Access Compliance Report
Public Rights-of-Way
(Curb Ramps)

Main Street: ERVIN_LN | **Cross Street: GIMBERT_LN** | **Location: NW**

ADA ID: RPRK220127132406 | **Ramp Type:Type 1 - Perpendicular Diagonal** | **Initial Pass/Fail: Pass** | **Overall Compliance: No** | **Severity Score: 0**

Codes/Mitigation Info/Possible Solution

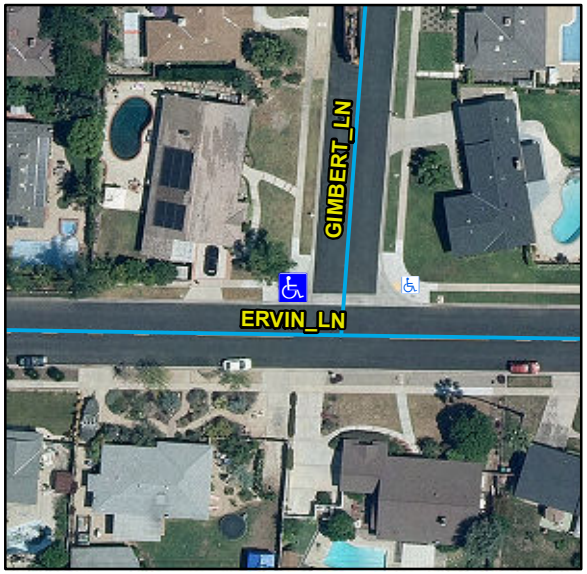
R304.2.2, R304.2.1, R304.2.2-Perp, R304.3.2-Para, R304.5.3, STD 1115

Remove & Replace Curb Ramp With Two New Directional Ramps or Equivalent. Remove & Replace Gutter.
